MOD2019/0585

PROJECT
TWO SEMI-DETACHED DWELLINGS
WITH BASEMENT CARPARKING:

52 LAUDERDALE AVENUE,
FAIRLIGHT, NSW

S4.55 AMENDMENTS:

WEST ELEVATION

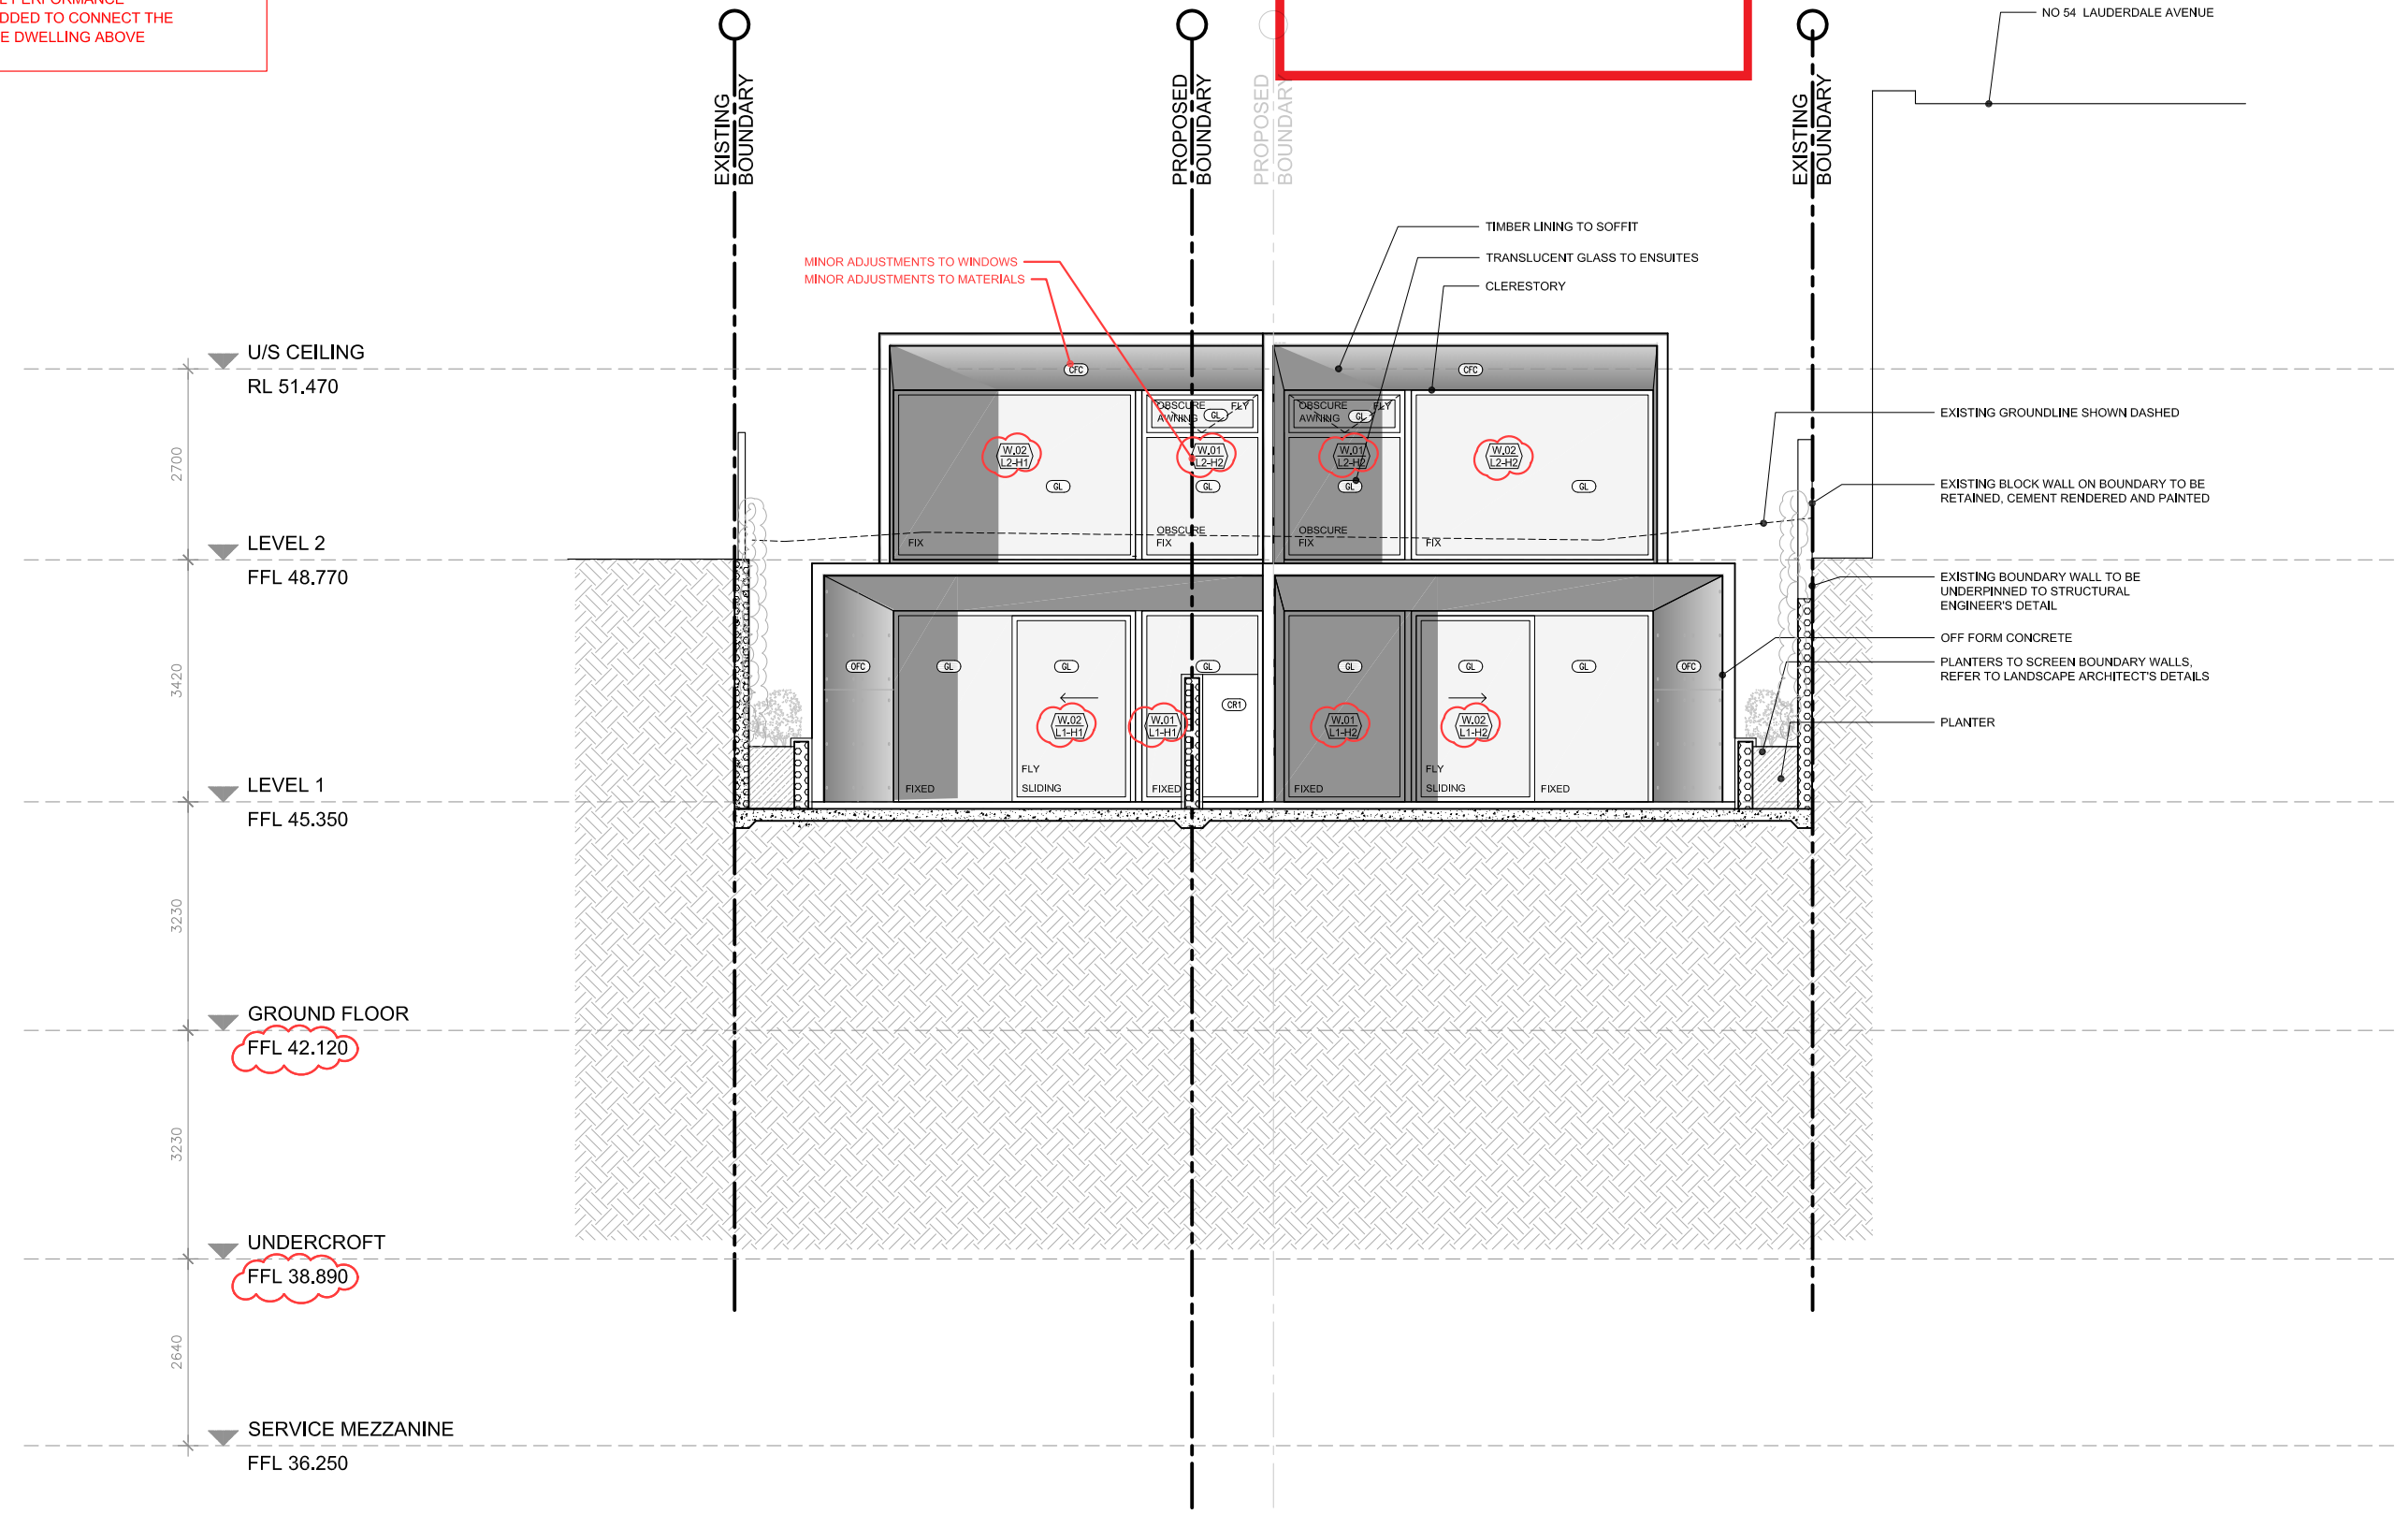
MINOR ADJUSTMENTS TO MATERIAL
MINOR ADJUSTMENTS TO WINDOWS
AIR SUPPLY TO HRV SYSTEM ———

- ADJUSTMENTS OF UNDERCROFT AND GROUND FLOOR LEVELS TO INCREASE CEILING ZONE TO ALLOW FOR AN HRV SYSTEM, OVERALL BUILDING HEIGHT STAYS THE SAME
- MINOR ADJUSTMENTS TO THE FENCE AND GARDEN AS A RESULT OF ABOVE
- MINOR EXTERNAL ADJUSTMENTS DUE TO ABOVE POINTS AND DECREASED WINDOW SIZES FOR IMPROVED THERMAL PERFORMANCE
- INTERNAL STAIR ADDED TO CONNECT THE BASEMENT WITH THE DWELLING ABOVE

DRAWING TITLE		PROJECT	
NORTH ELEVATION		LAF	
SCALE	STATUS	NUMBER	REVISION
1:100 @A3	s4.55	A2.03	P1

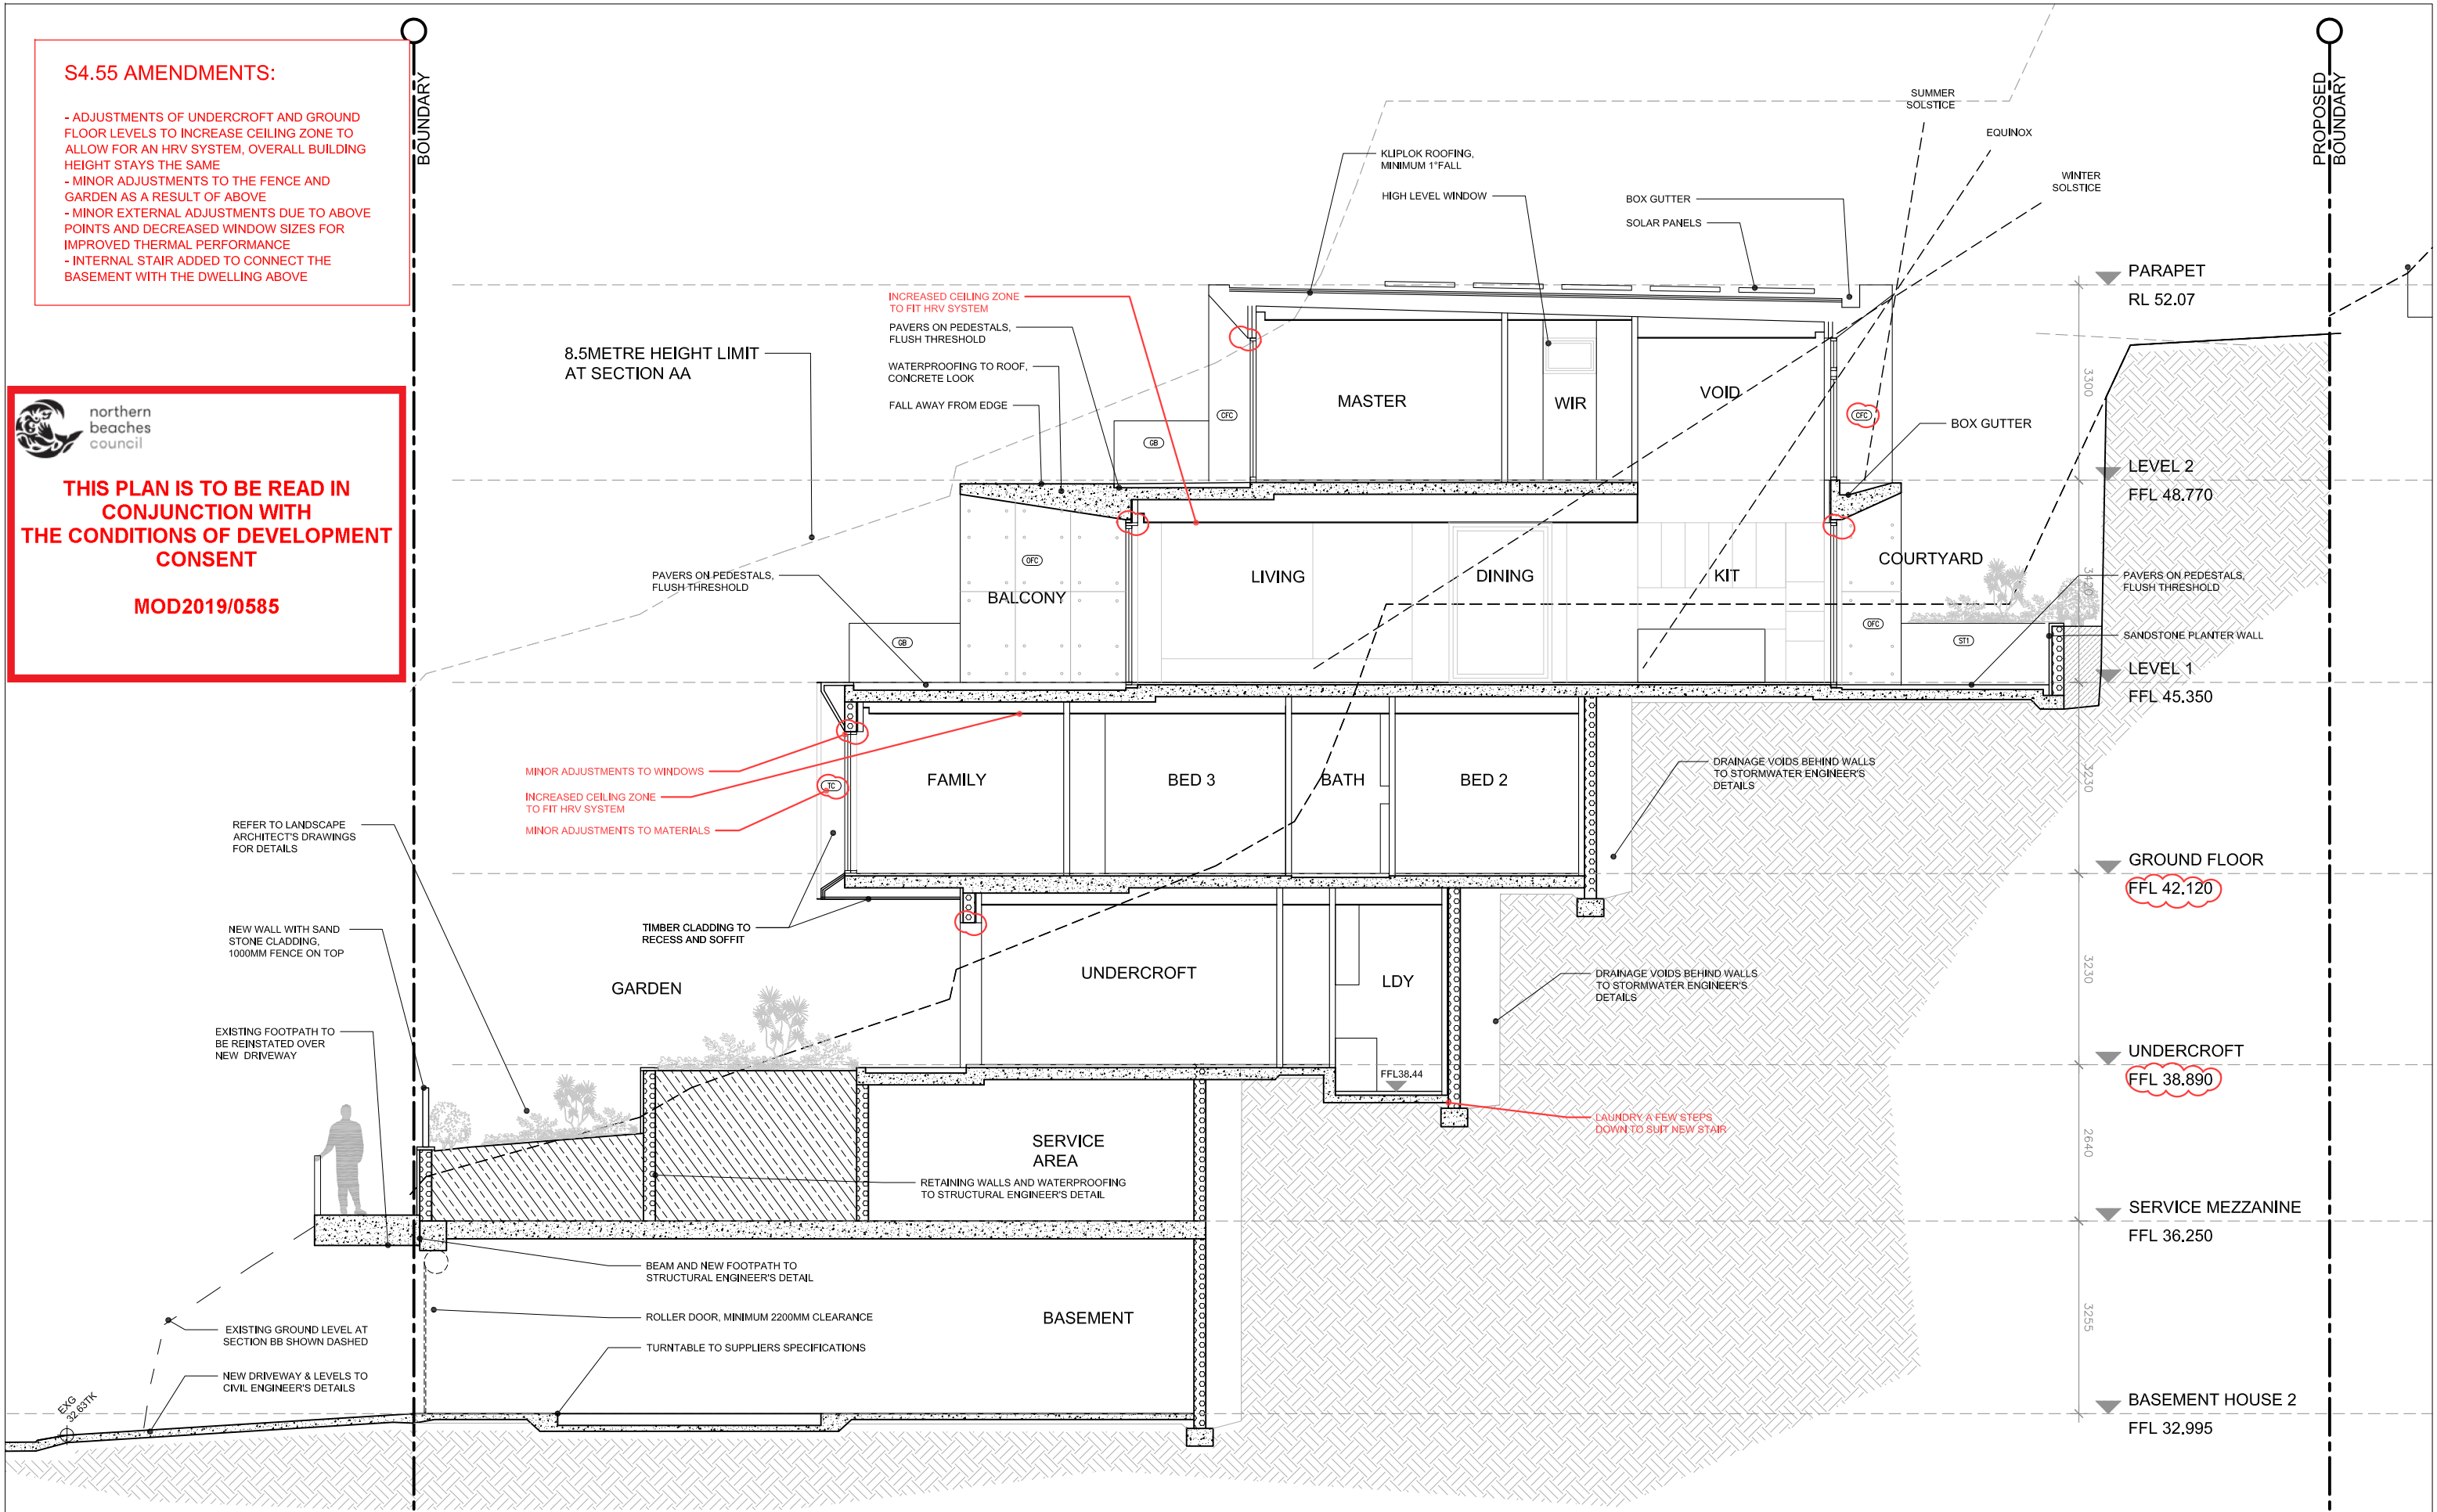
- ADJUSTMENTS OF UNDERCROFT AND GROUND FLOOR LEVELS TO INCREASE CEILING ZONE TO ALLOW FOR AN HRV SYSTEM, OVERALL BUILDING HEIGHT STAYS THE SAME
- MINOR ADJUSTMENTS TO THE FENCE AND GARDEN AS A RESULT OF ABOVE
- MINOR EXTERNAL ADJUSTMENTS DUE TO ABOVE POINTS AND DECREASED WINDOW SIZES FOR IMPROVED THERMAL PERFORMANCE
- INTERNAL STAIR ADDED TO CONNECT THE BASEMENT WITH THE DWELLING ABOVE

DRAWING TITLE		PROJECT	
DRIVEWAY ELEVATION		LAF	
SCALE	STATUS	NUMBER	REVISION
1:100 @A3	\$4.55	A5.03	S4.55

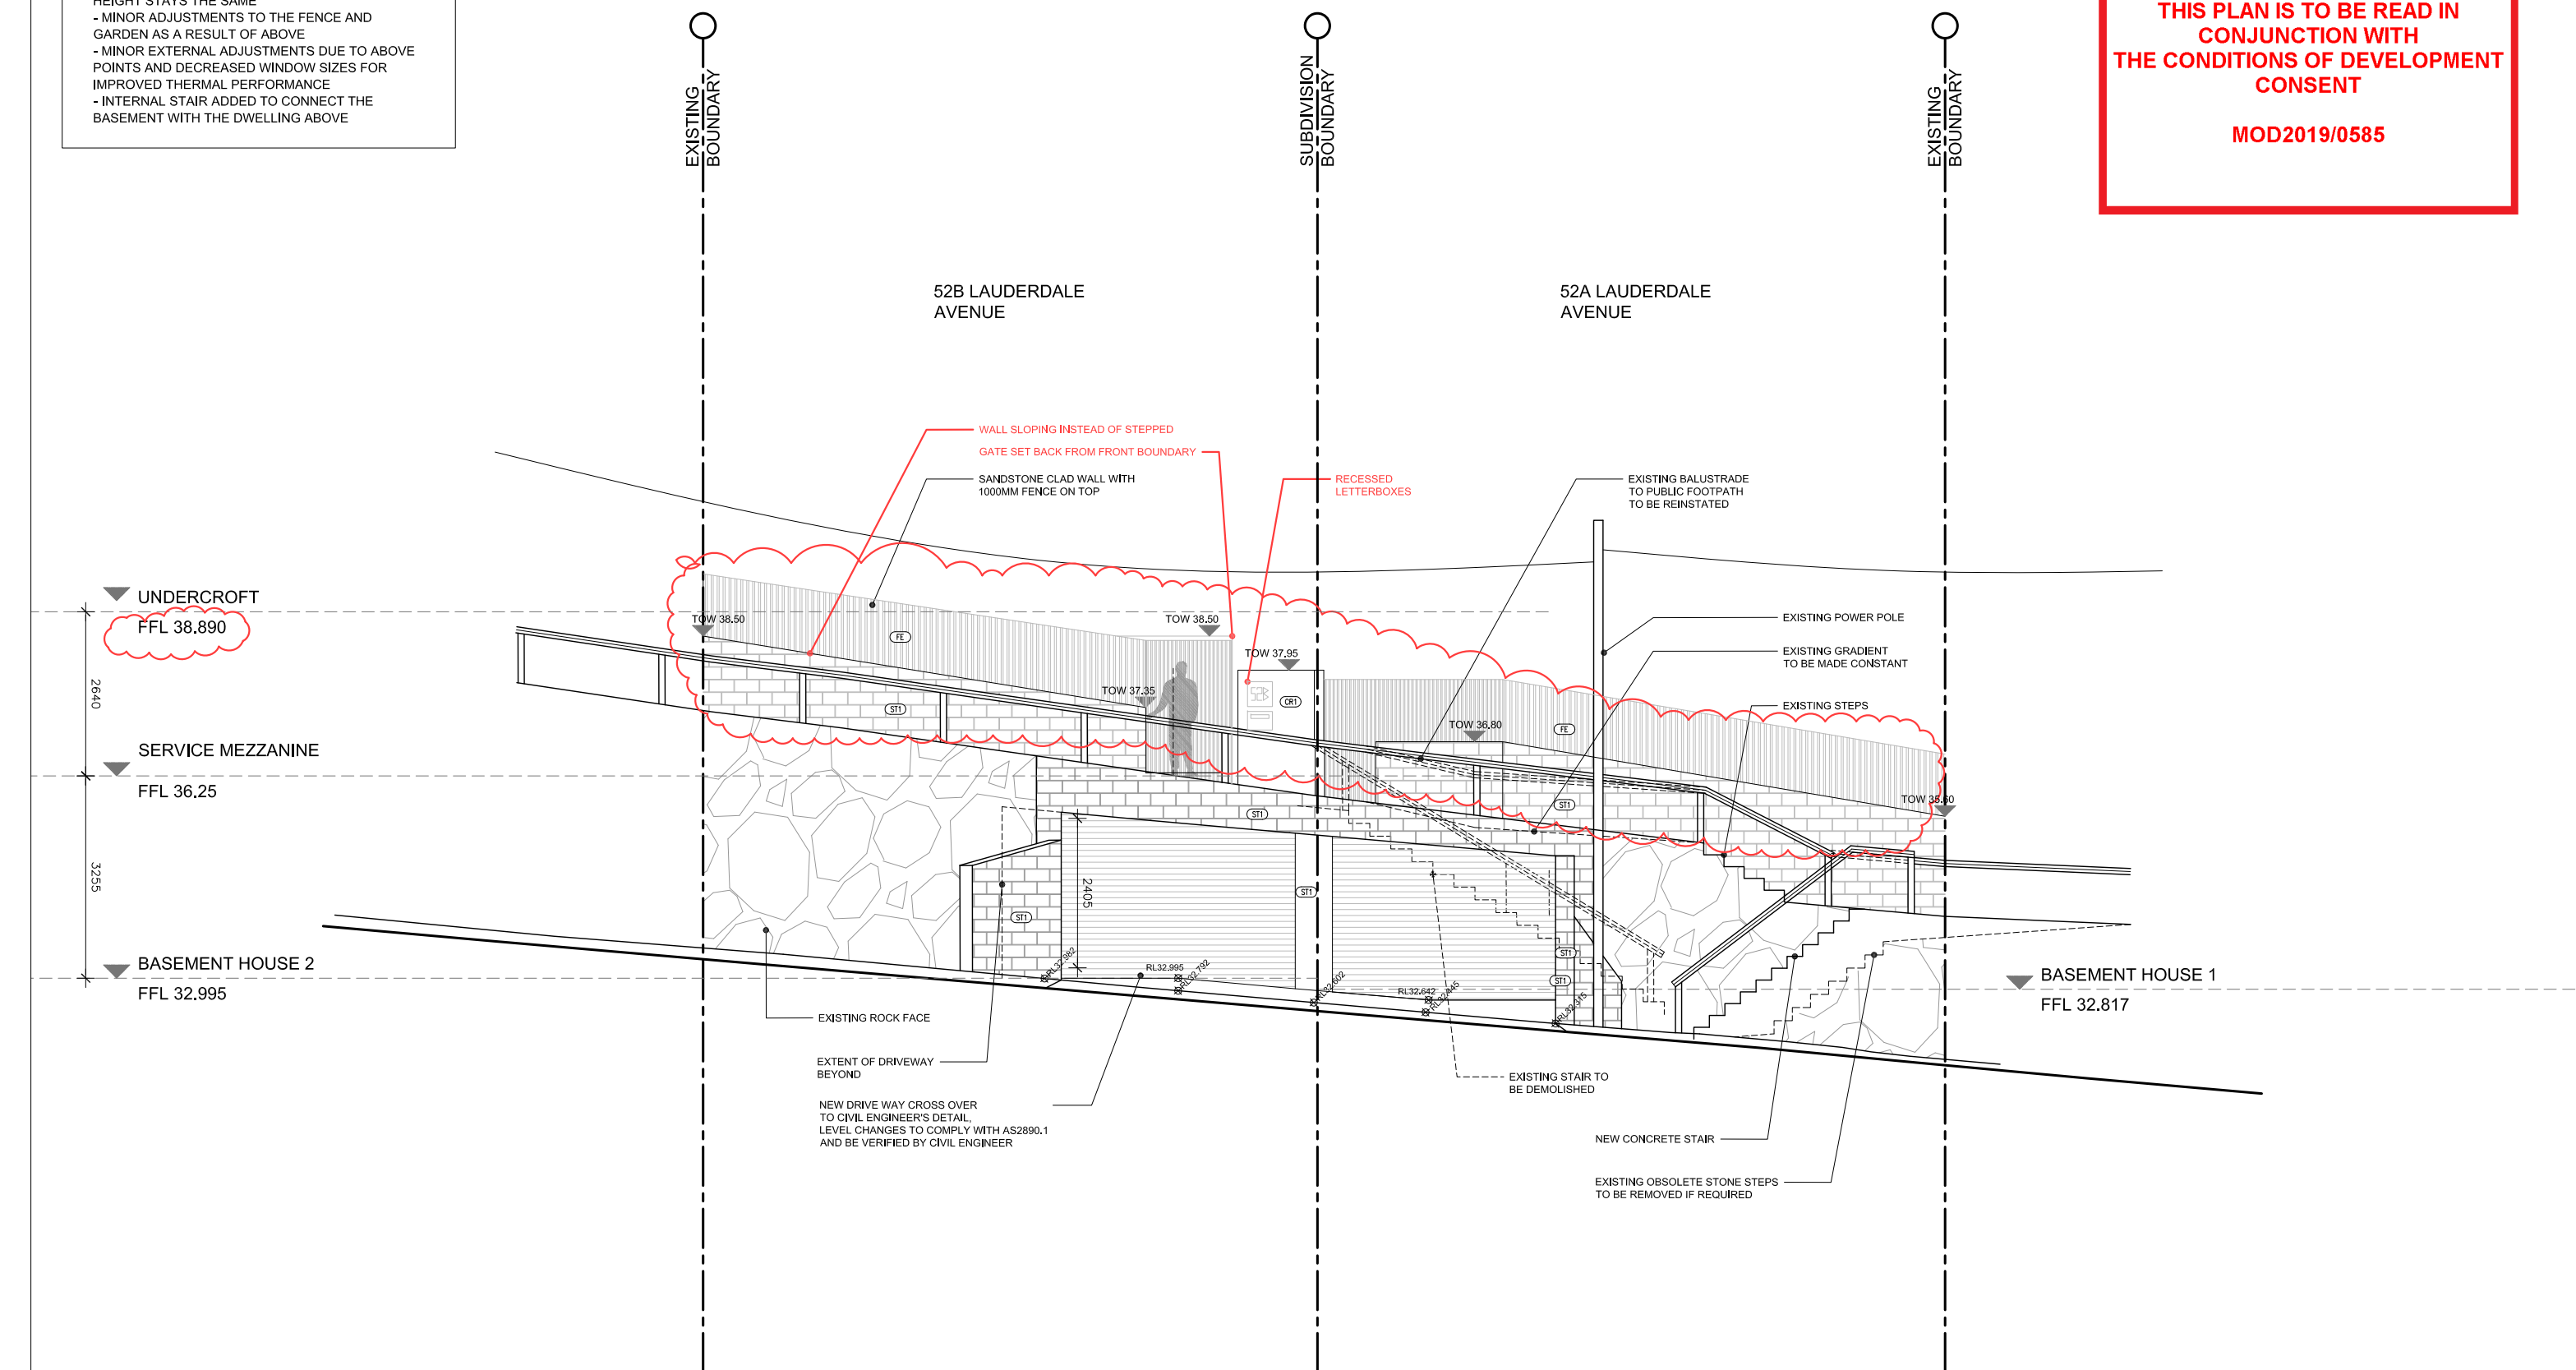
- ADJUSTMENTS OF UNDERCROFT AND GROUND FLOOR LEVELS TO INCREASE CEILING ZONE TO ALLOW FOR AN HRV SYSTEM, OVERALL BUILDING HEIGHT STAYS THE SAME
- MINOR ADJUSTMENTS TO THE FENCE AND GARDEN AS A RESULT OF ABOVE
- MINOR EXTERNAL ADJUSTMENTS DUE TO ABOVE POINTS AND DECREASED WINDOW SIZES FOR IMPROVED THERMAL PERFORMANCE
- INTERNAL STAIR ADDED TO CONNECT THE BASEMENT WITH THE DWELLING ABOVE
